CERTIFICATE OF APPROPRIATENESS

Property: Lot 6, Block 289, Houston Heights Subdivision, City of Houston, Harris County, Texas. The site includes a 1,370 square foot contributing residence situated on a 6,600 square foot (50 x 132) lot.

Proposal: Alteration – Addition – *Revision* The applicant was granted a COA on December 12, 2013 to construct a two story addition.

**NORTH SIDE ELEVATION
PREVIOUSLY EXISTING**

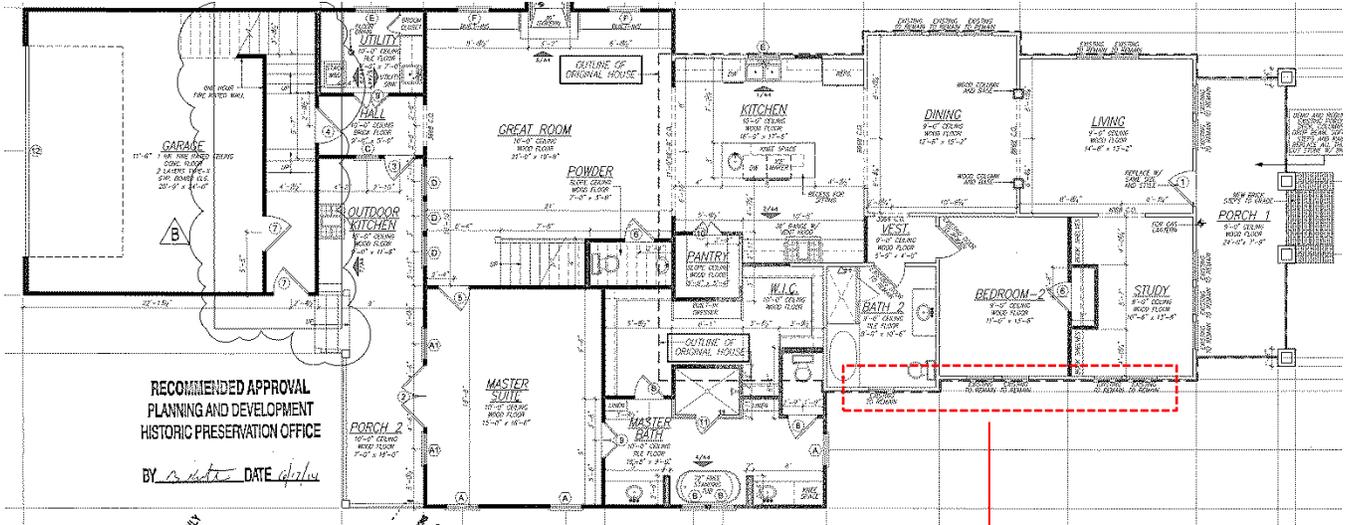
16' deep section of new wall material and cladding

FIRST FLOOR PLAN

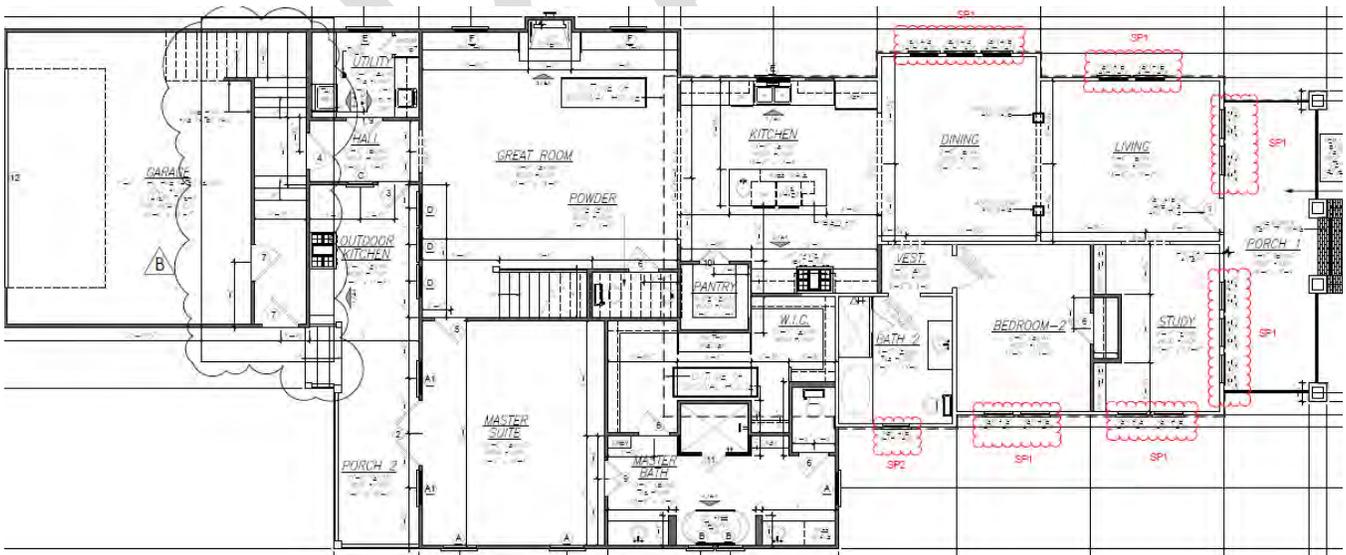
Existing to Remain notes by each window

DEMOLITION PLAN

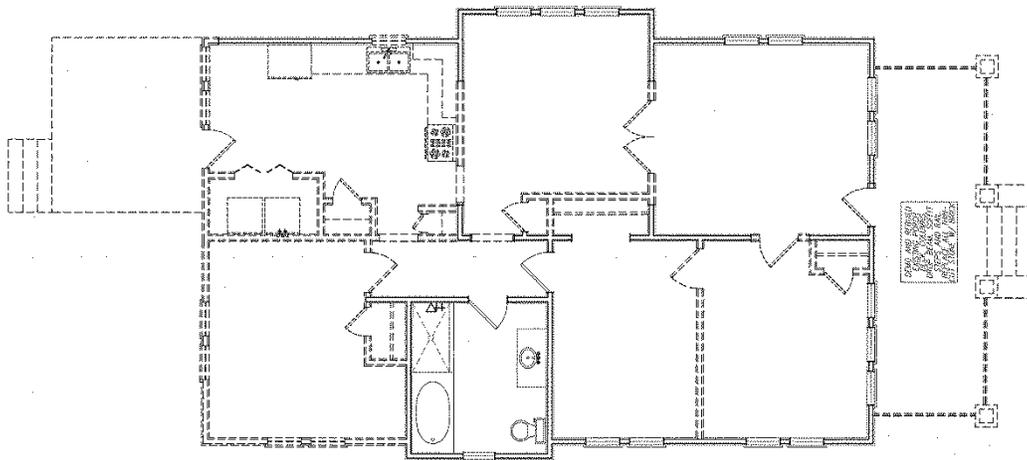
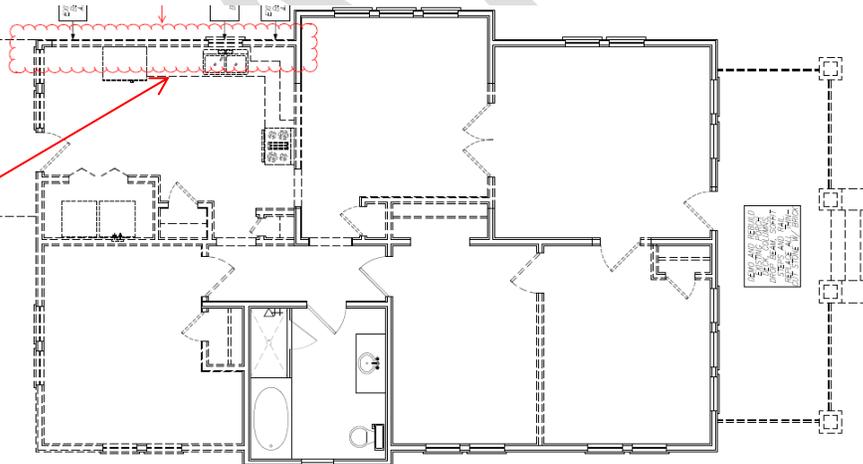
Existing wall at kitchen had to be re-framed due to the kitchen window being relocated 2' towards the back of the home. Additional support for window and second floor framing were needed for structural integrity.

ROOF PLAN

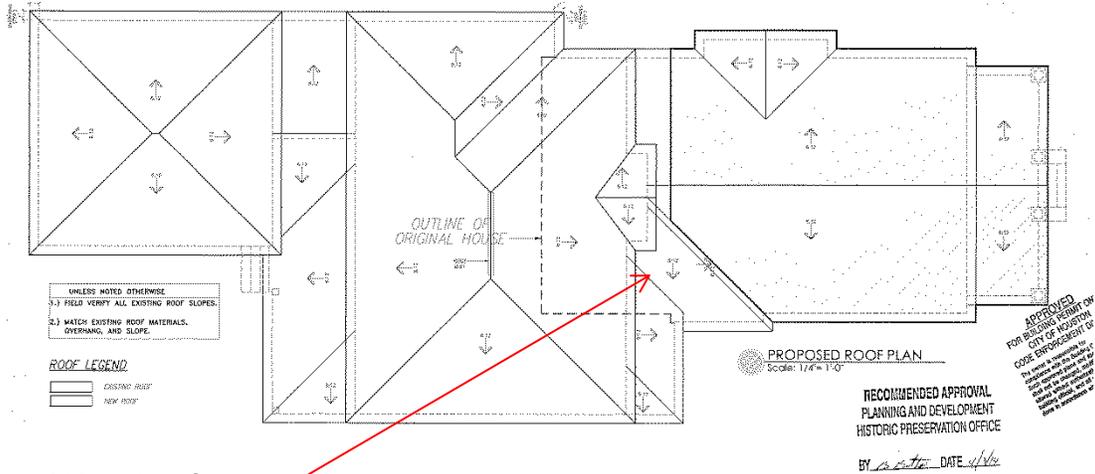
Approved hipped roof over south facing bump out

Roof: The existing south facing bump out originally featured a side facing gable. The applicant was approved to remove this gable and replace it with a hipped roof. The applicant now proposes to eliminate the hipped roof over the bump out and instead extend the existing front open gable roof structure to the rear to cover the bump out.
